Peach Bottom Atomic Power Station, Units 2 and 3
Renewed Facility Operating License Nos. DPR-44 and DPR-56
NRC Docket Nos. 50-277, and 50-278

Subject: Supplemental Information Concerning License Amendment to Allow Receipt and Storage of Low-Level Radioactive Waste at Peach Bottom Atomic Power Station, Units 2 and 3

Response to Requests for Additional Information Concerning License Amendment to Allow Receipt and Storage of Low-Level Radioactive Waste at Peach Bottom Atomic Power Station, Units 2 and 3 Renewed Facility Operating Licenses DPR-44 and DPR-56

Figure 3: Design Basis Analysis – Controlling Skyshine Dose from LLRWSF

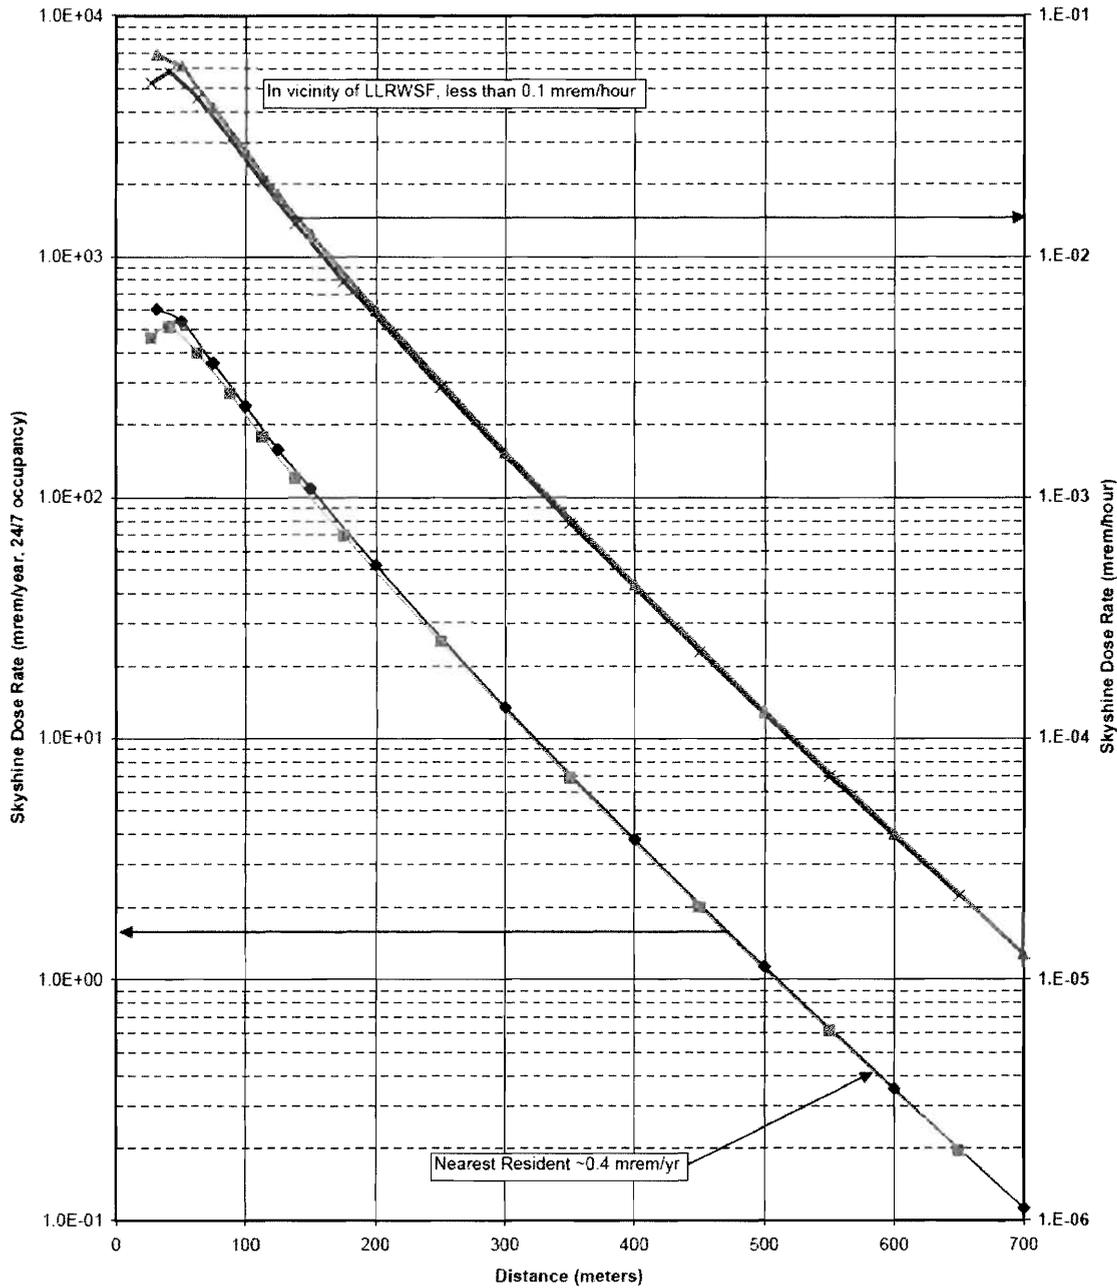
"For offsite radiation protection considerations under 10 CFR 20.1301(e), explain the methods used in the Offsite Dose Calculation Manual methods to measure and/or calculate the net dose at the nearest residence attributable to the LLW Storage Facility and those doses attributable to the nuclear site from other sources of the direct radiation. For the environmental monitoring dosimeters, describe how the background (baseline) radiation dose will be (or has been) determined, how the standard deviation at each environmental dosimeter location has been determined, and the estimated Lower Limit of Detection for dosimeters that can be achieved at the 95% confidence level."

The PBAPS LLRWSF is a heavily shielded structure that has been analyzed with bounding design basis assumptions on building loading and container radioactivity. The methodology for this analysis is described in Reference 1, Attachment 3, "Peach Bottom LLRWSF LAR Support, Technical Report Supporting Engineering Change Request (ECR) No. 09-00301," Section 8.5.3, "Shielding Analysis Methodology." In the shielding analysis, skyshine is the controlling phenomenon for offsite locations. The source term assumptions in the analysis included 400 R/hr contact dose rates on containers in the interior 15 cells and 125 R/hr contact dose rates on containers in peripheral cells. LLRWSF loading and liner placement procedures will ensure that dose rates on the exterior surface of the LLRWSF will be maintained less than 1 mrem/hr.

The calculated dose rates versus distance from center of the LLRWSF is depicted in Figure 3, "Design Basis Analysis – Controlling Skyshine Dose from LLRWSF." The calculated dose rate at the nearest residence is 0.4 mrem/year. This location is approximately 585 meters from the modeled waste center and, although principally used as a summer residence, was evaluated with 100% occupancy. The nearest full-year residence, which is not shown on Figure 1, is approximately 620 meters from the modeled waste center, with a calculated dose rate of 0.3 mrem/year.
